VOLUME II

APPENDIX 10J

Route Modification Tables and Figures ***Update April 2016***

Rover Pipeline Project
Figure 10J-48a
Mainlines A and B Variation ML35

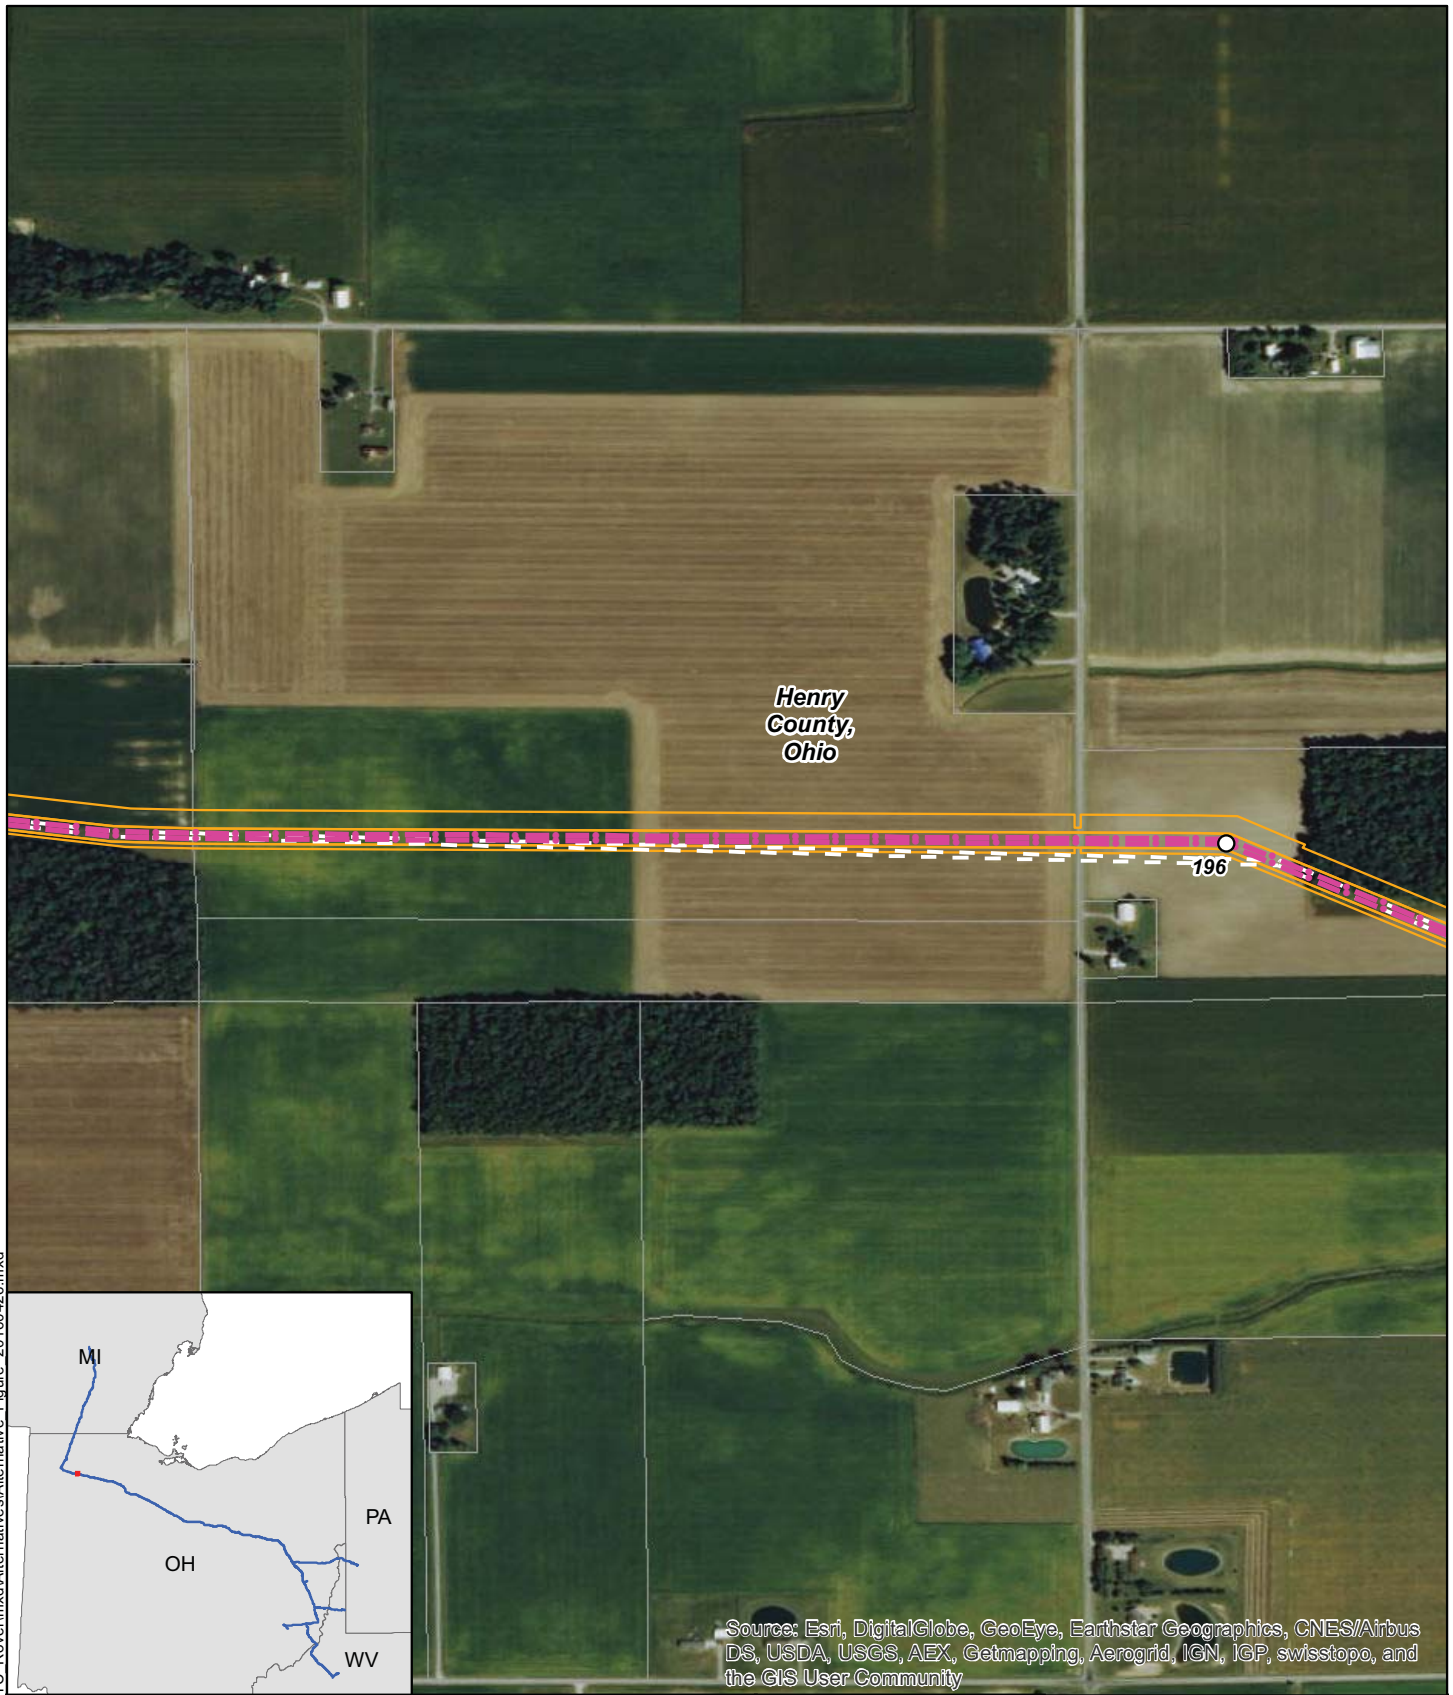
195.94	196.55	0.60	0.61	85	ML35	Accommodate landowner request.	Figure 10J-48a; Table 10J-48a
	201.09	201.84	0.75	0.76	350	ML33	Avoid forested wetland tract.	Figure 10J-49, Table 10J-49
Mainline A	202.14	202.71	0.58	0.59	67	ML34	Adjust angle of existing pipeline crossing.	Figure 10J-50, Table 10J-50

Rover Pipeline Project
Figure 10J-50a
Mainline A Variation ML36

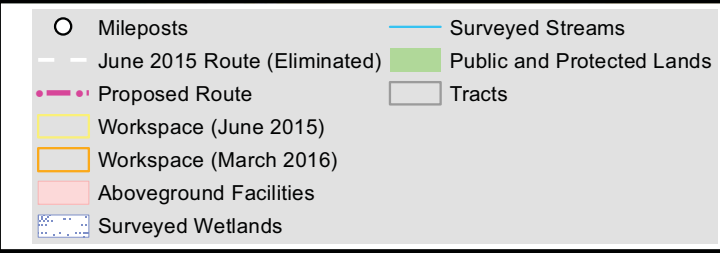
206.41	207.27	0.85	0.91	55085	ML36	Accommodate landowner request.	Figure 10J-50a; Table 10J-50a
Market Segment	0.15	0.34	0.19	0.2	43	MS26	Avoid concrete bulkhead at drain tile header.	Figure 10J-51, Table 10J-51
